Access Compliance Report

Public Rights-of-Way

(Curb Ramps)

Intersection ID: 14468	Main Street: EUCLID_AV	Cross Street: E TREMONT AV	Location:	N
ADA ID: 7093D30F1522	Ramp Type: Directional1	Initial Pass/Fail: Fail	Overall Compliance: No	Severity Score: 13.75

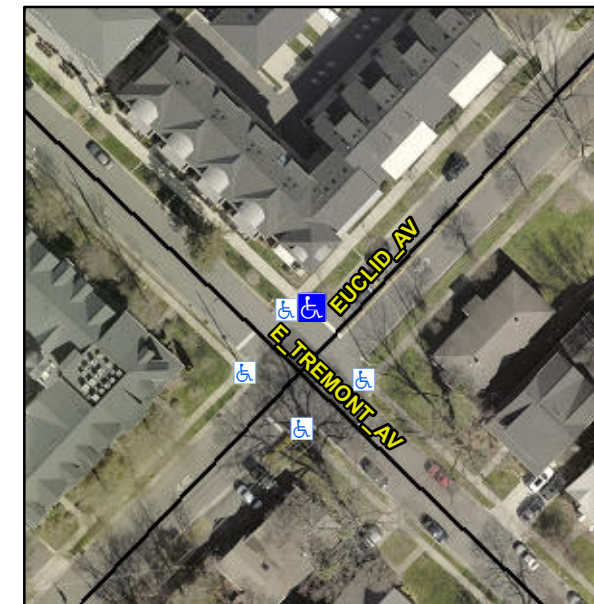
R304.2.2, R304.5.3

Compliance	Description	Data	Compliance	Description	Data
N/A	Ramp Length (in)	74.0	N/A	Grade Break?	N/A
Yes	Ramp Width (in)	69.0	N/A	Grade Break Slope (%)	0.0
No	Ramp Slope (%)	8.6	N/A	Grade Break XSlope (%)	0.0
No	Ramp XSlope (%)	3.8			
N/A	Flare Type LT	N/A	N/A	Flare Type RT	N/A
N/A	Flare Slope LT (%)	N/A	N/A	Flare Slope RT (%)	0.0
N/A	Flare Traversable LT?	N/A	N/A	Flare Traversable RT?	N/A
N/A	Landing Length (in)	0.0	N/A	DWS Provided?	N/A
N/A	Landing Width (in)	0.0	N/A	DWS Contrast?	N/A
N/A	Landing Slope (%)	0.0	N/A	DWS Length (in)	N/A
N/A	Landing X Slope (%)	0.0	N/A	DWS Full Width?	N/A
N/A	Landing Curb? (Y/N)	N/A	N/A	DWS Offset LT (in)	N/A
N/A	Shared Landing?	N/A	N/A	DWS Offset RT (in)	N/A
N/A	Gutter Ponding?	0.0	N/A	Gutter Slope (%)	N/A
N/A	Gutter Lip Ht (in)	0.0	N/A	Gutter X Slope (%)	N/A
N/A	Painted X Walk1?	No		Road Slope (%)	0.8
	X Walk 1 Direction	To SE		Road X Slope (%)	3.6
	X Walk 1 Width (in)	N/A		Clear Space?	N/A

Remove & Replace Entire Ramp.
